<b>TO:</b>	<b>Dr. Cone,</b> Superintendent of Schools, LVISD	<b>FROM:</b>	<b>Catherine Blackler</b> <i>Catherine Blackler</i> Senior Project Manager, AGCM
<b>cc:</b>	Belinda Raindl, LVISD		Michael Rogers, AGCM
<b>RE:</b>	La Vernia ISD – Bond 2023	<b>DATE:</b>	June 18, 2025
<b>SUBJECT:</b>	PR No. 08	<b>PR DATE:</b>	April 25, 2025
<b>PR COST:</b>	\$ 8,128.00	<b>CONTRACTOR:</b>	Bartlett Cocke (RCO 13R1)

Architect's Project Number: 22075  
Proposal Request Number: 08  
Proposal Request Date: April 25, 2025

**PR No.:** 08 / Delta 18  
**Date:** 04/11/2025  
**Project:** La Vernia ISD Renovations  
**Number:** 25480

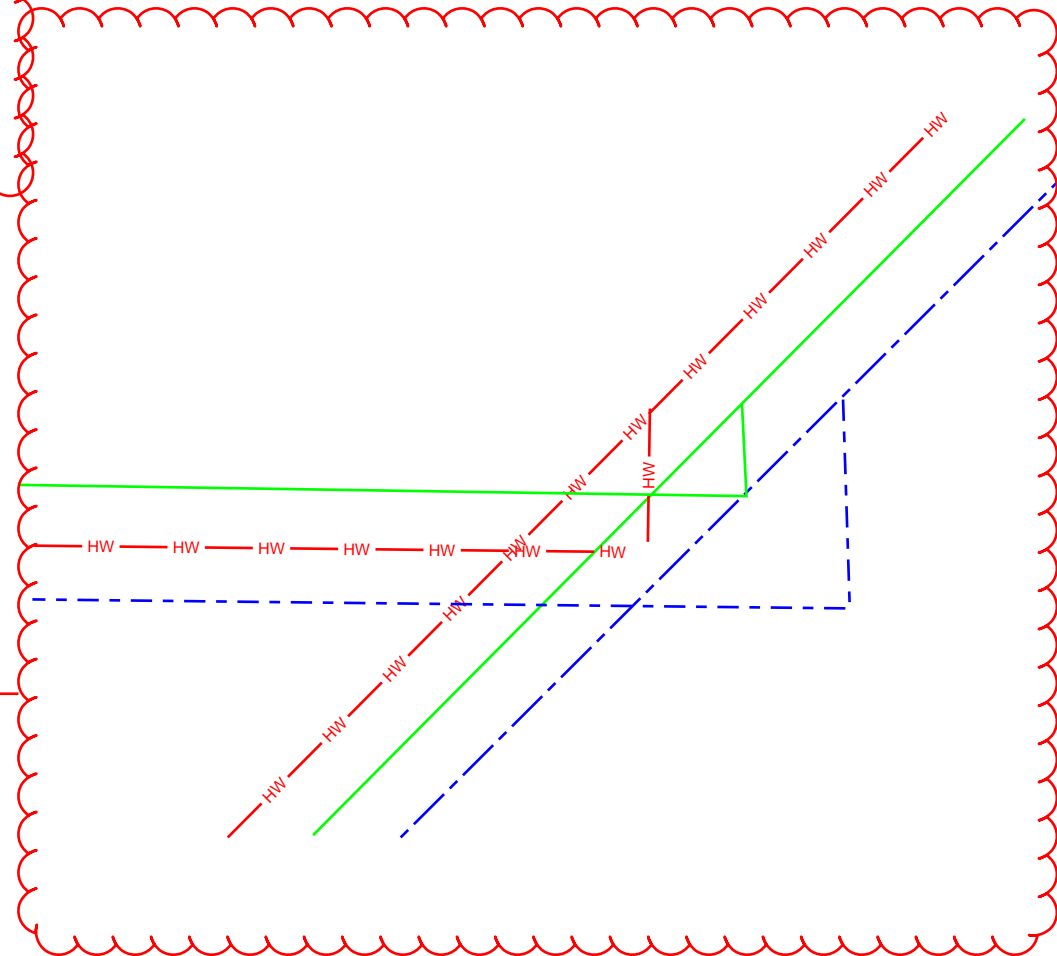
There is no clear indication that ¾" copper pipe is required for the lavatory and washing machine box.

Please see the attached comments on your pricing from the owner's rep. Please identify where the ¾" copper piping is, if it is a vertical piece just please make note of that. Please also provide a definition of consumables whenever you include it on a quote so we avoid repeating this with future changes. I will handle the BIM questions.

However, based on past installations, running ¾" copper and reducing to ½" at the fixture has proven sufficient. The last thing we want as a team is too undersize the line and risk it not meeting demand—especially during a full wash cycle at the washer. To avoid performance issues, I chose to run full-size ¾" copper to the general area, then reduce to ½" near the lavatory and washer box, matching the specified fixture connection size.

1 UNDERFLOOR PLAN - JUNIOR HIGH -  
AREA A-1 - PLUMBING  
1/8" = 1'-0"

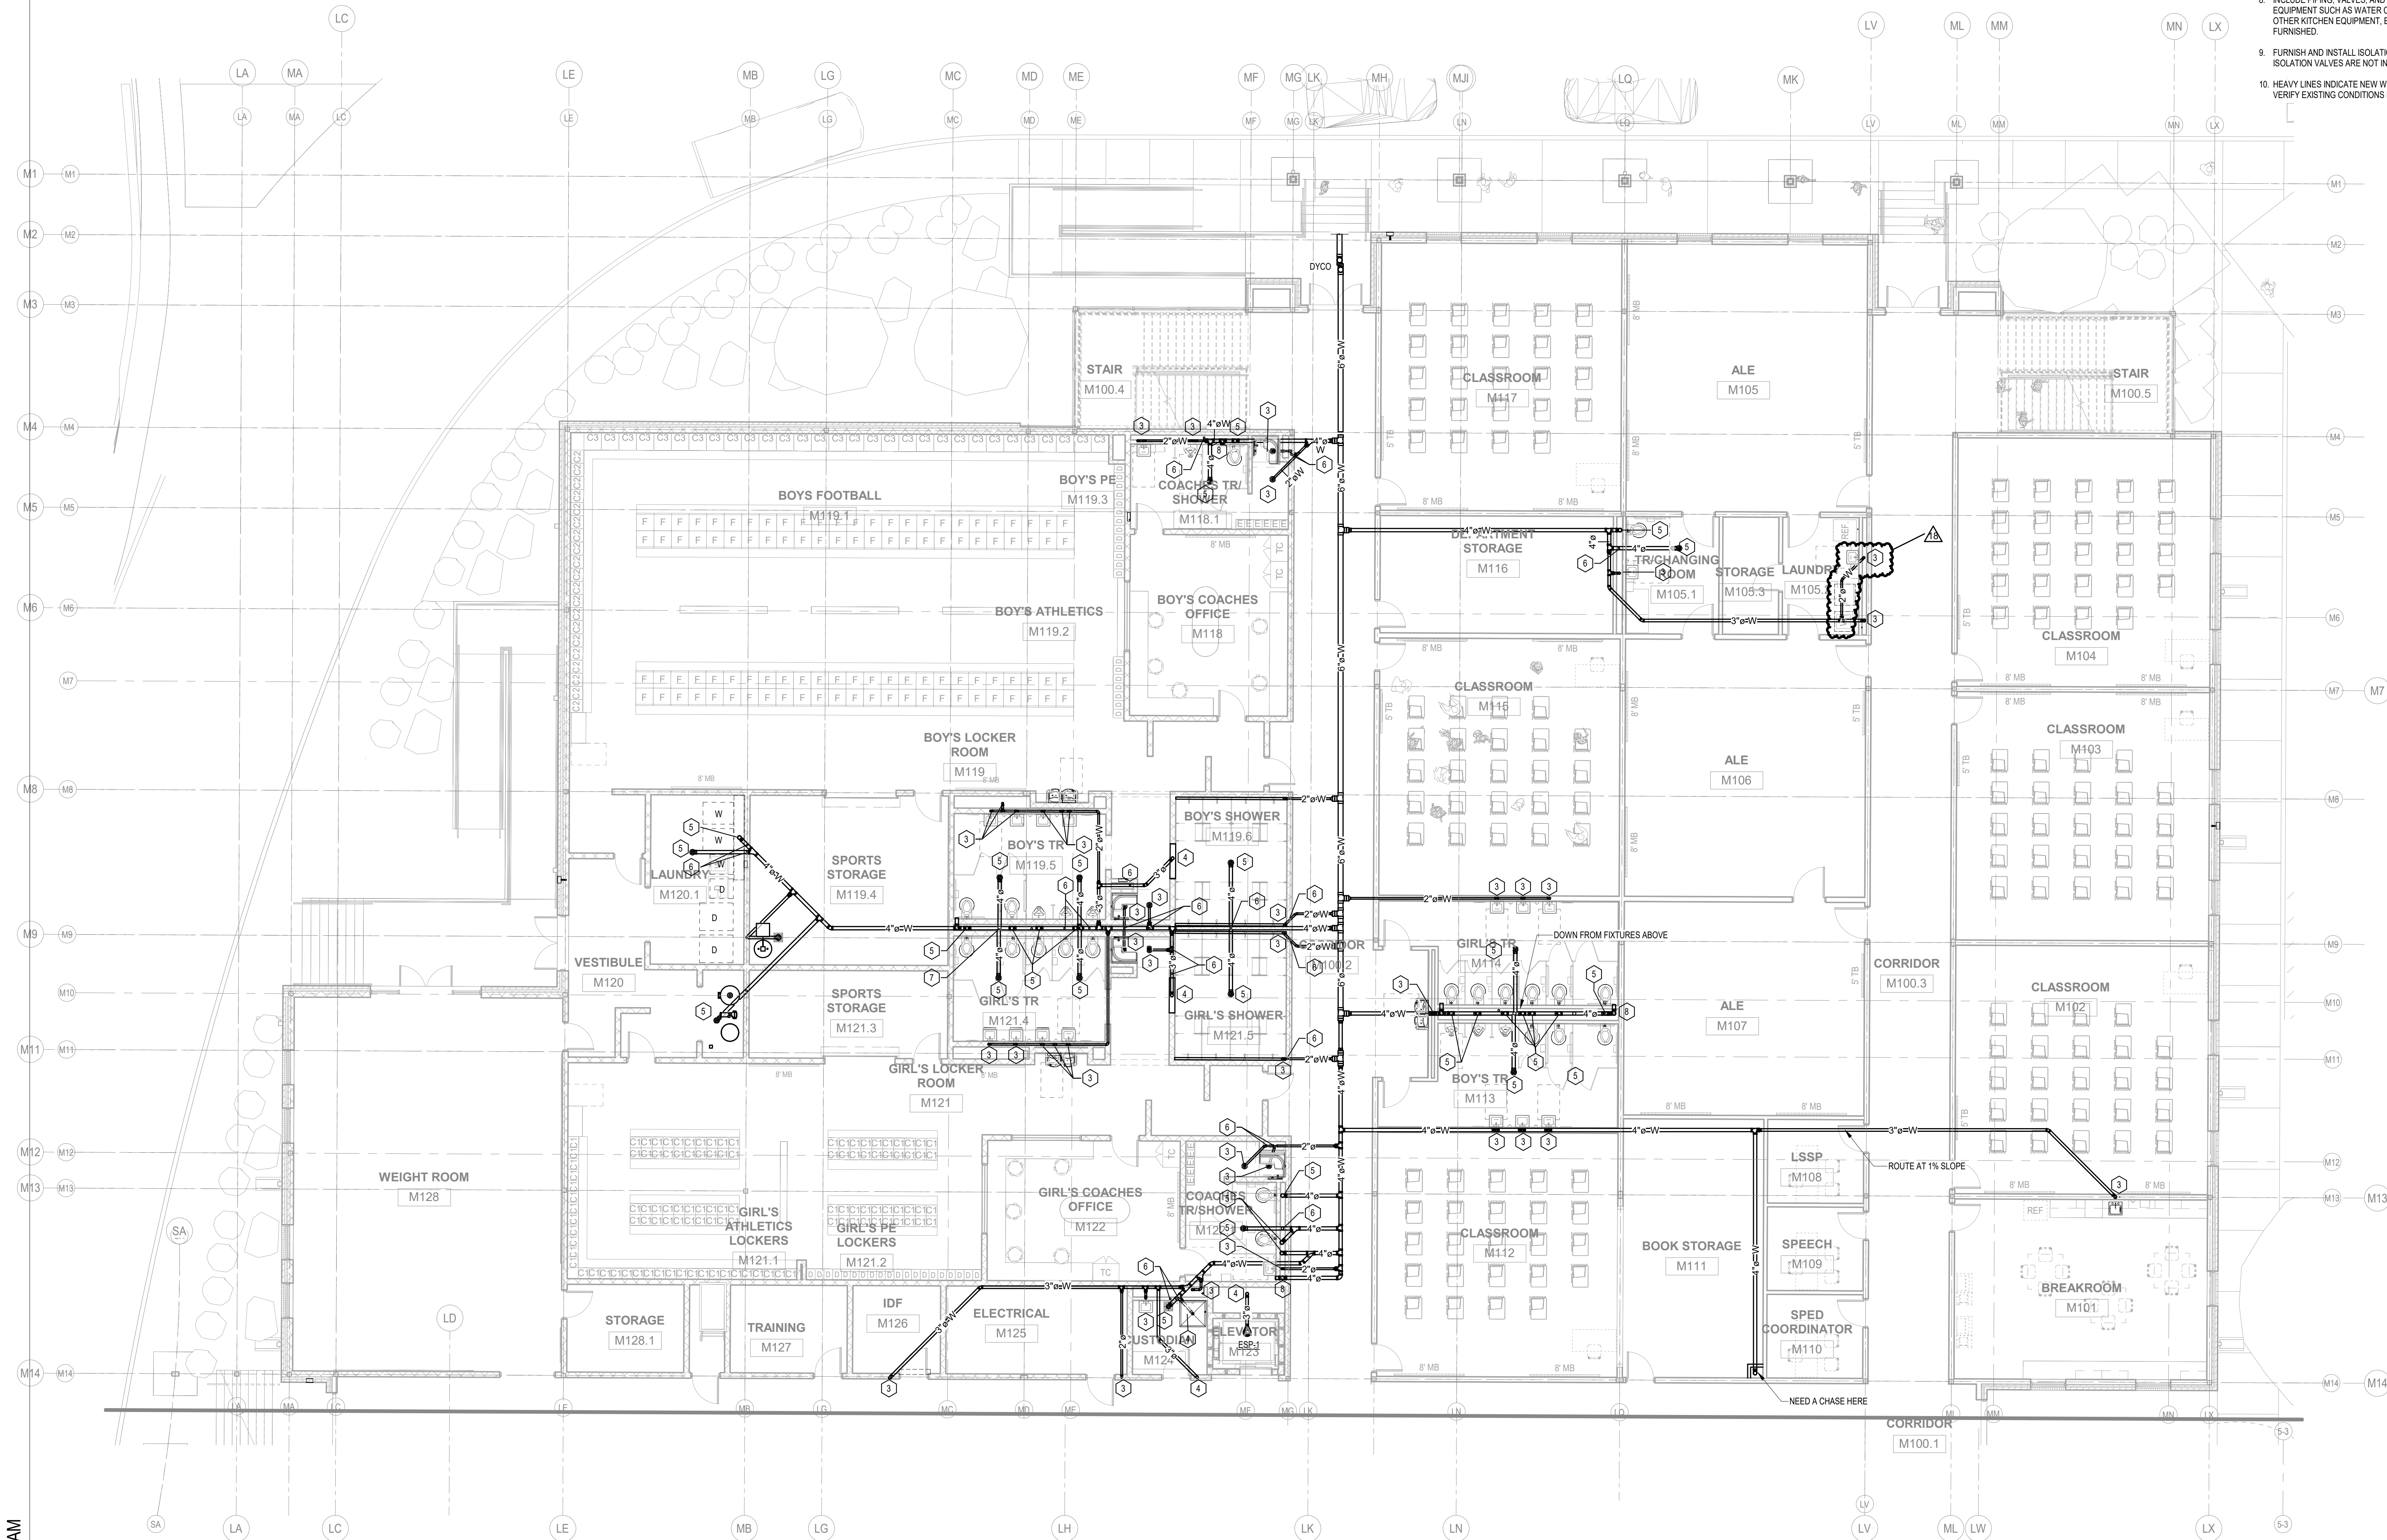
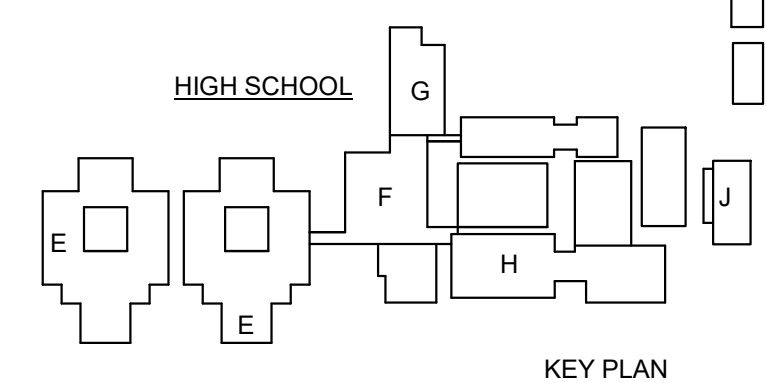
P1.1M – UNDERFLOOR PLAN – JUNIOR HIGH – AREA A-1 – PLBG

1. Add 2" waste to serve hand sink at Laundry Room M105.2 as shown on attached, revised sheet.

FIRST FLOOR - JUNIOR HIGH - AREA A-1  
- PLUMBING  
1/8" = 1'-0"

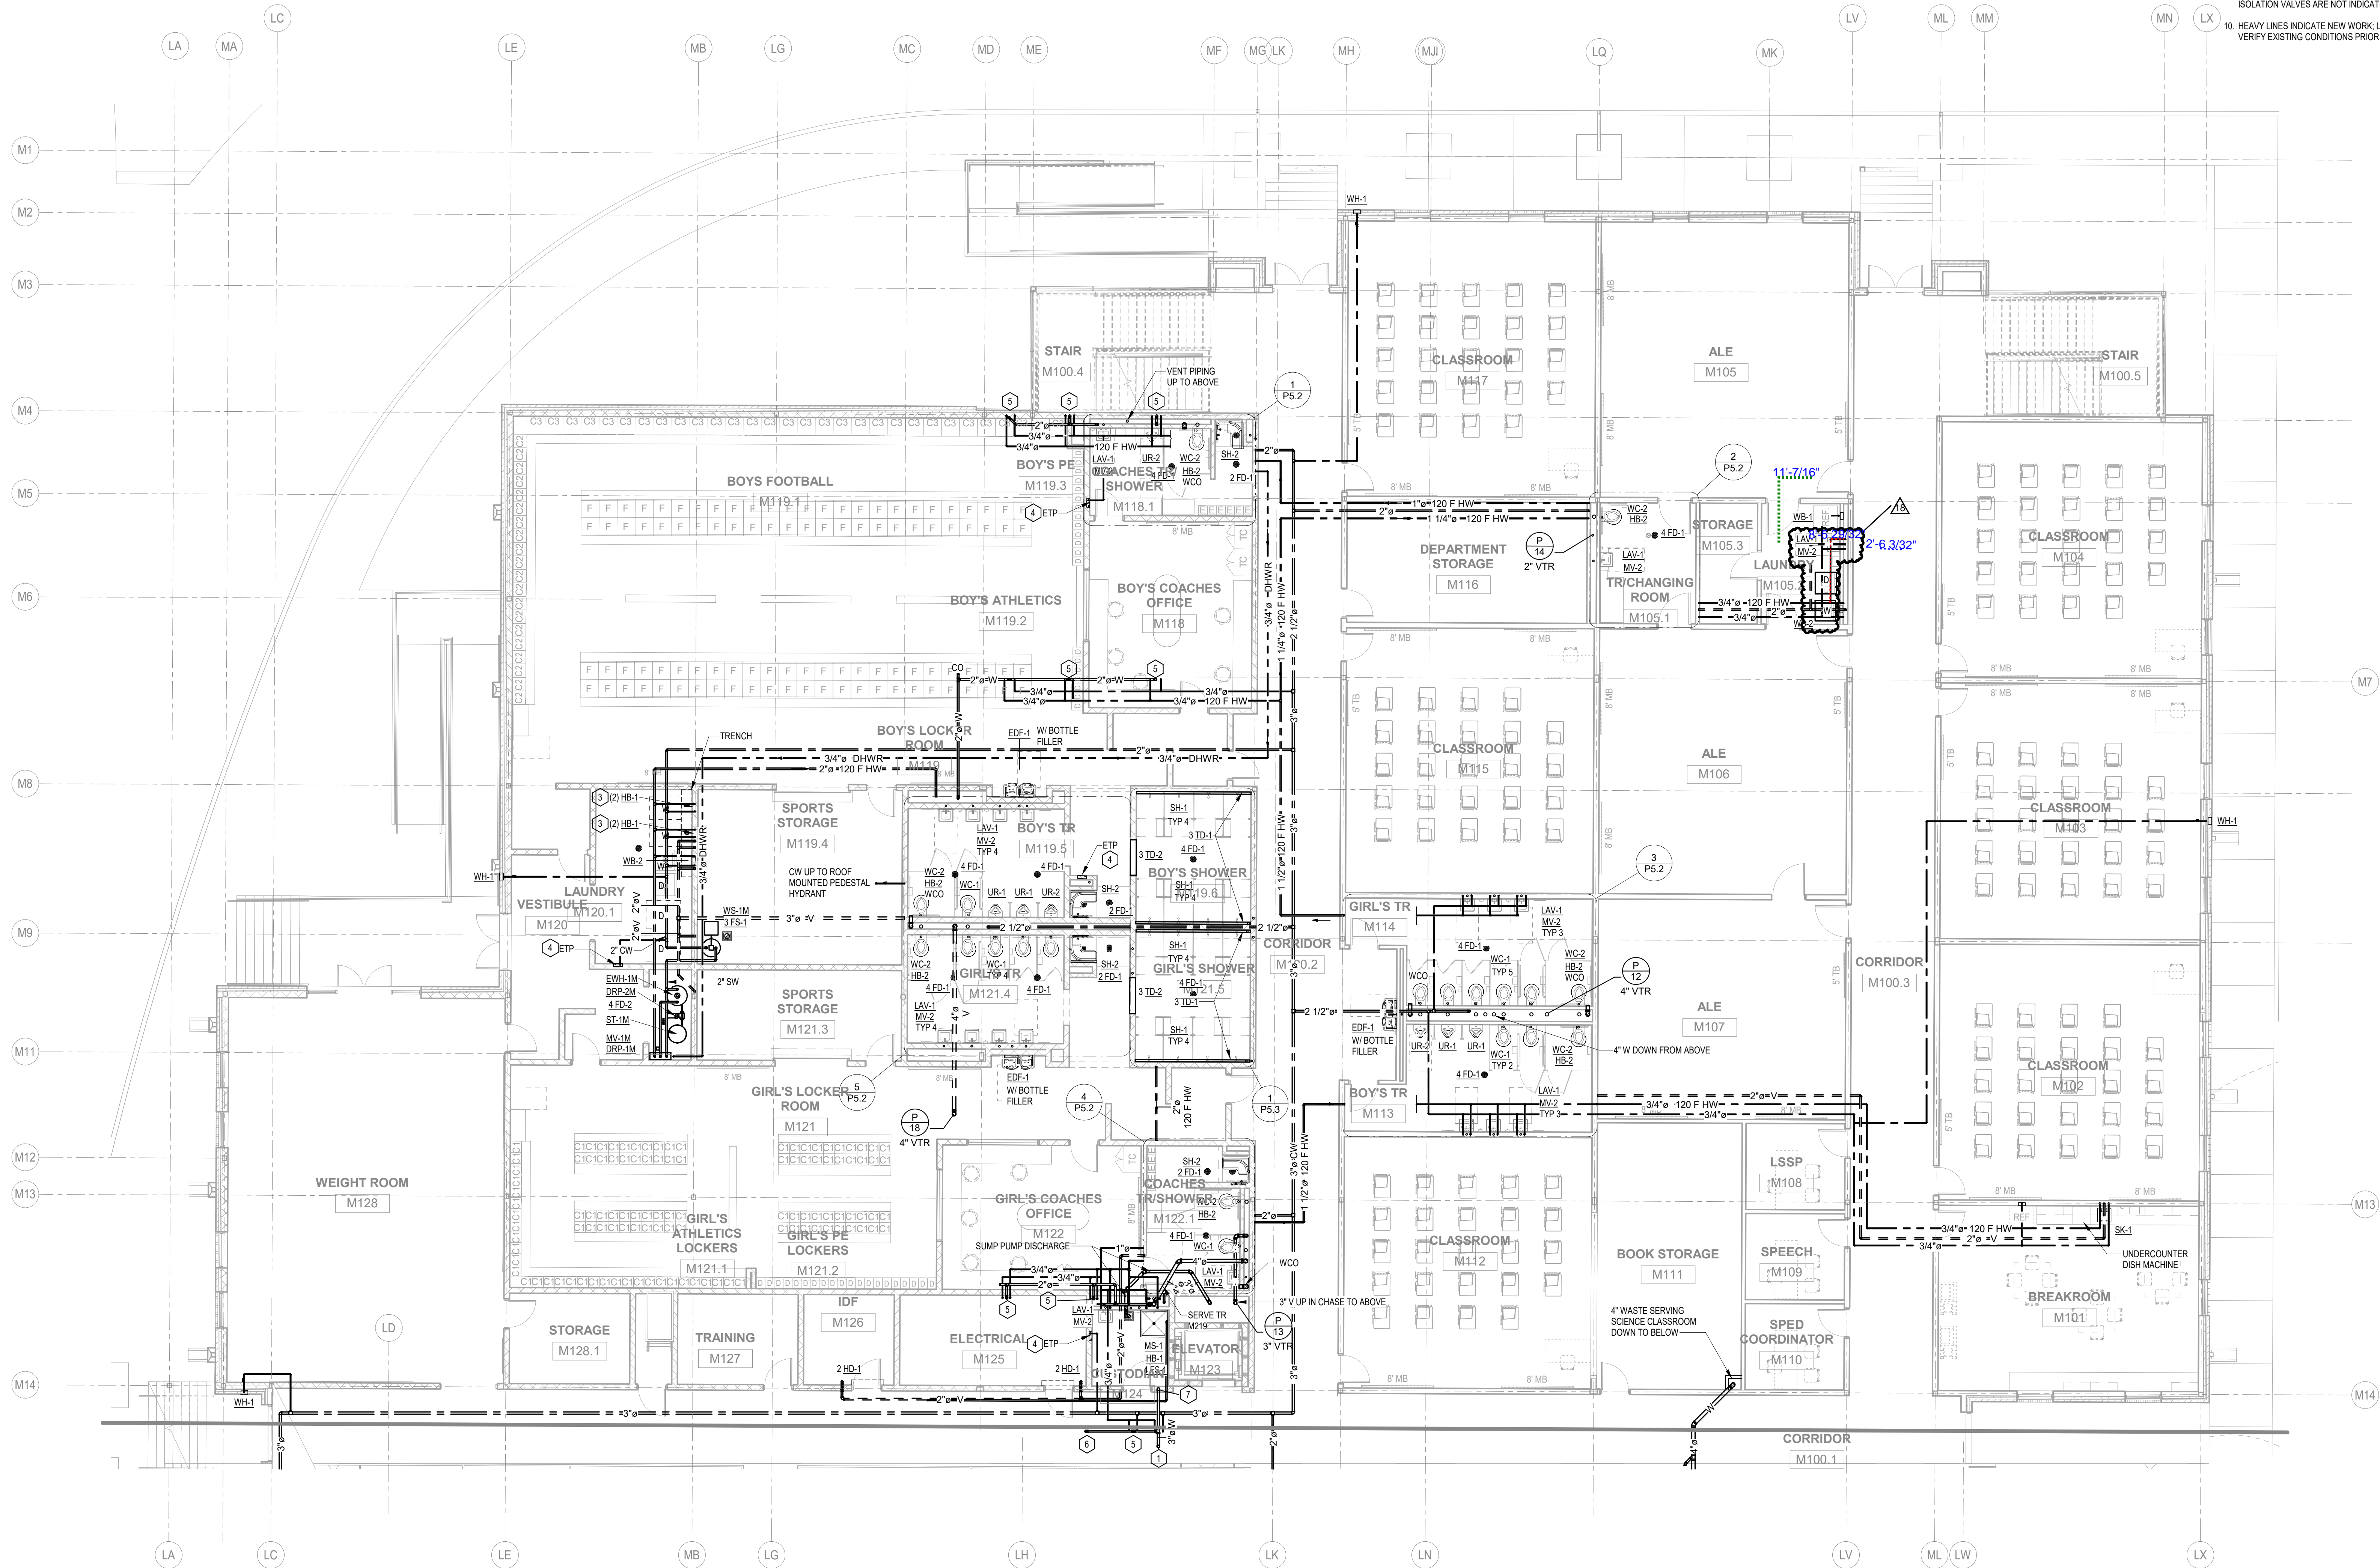
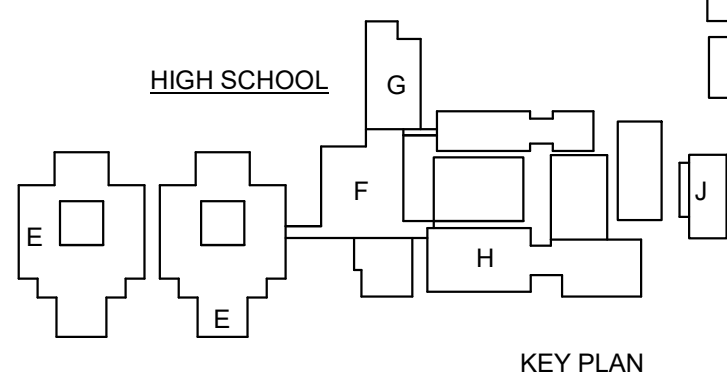
P2.1M – FIRST FLOOR – JUNIOR HIGH – AREA A-1 – PLBG

1. Add 2" Vent, 1/2" CW, & 1/2" HW to serve hand sink at Laundry Room M105.2 as shown on attached revised sheet.
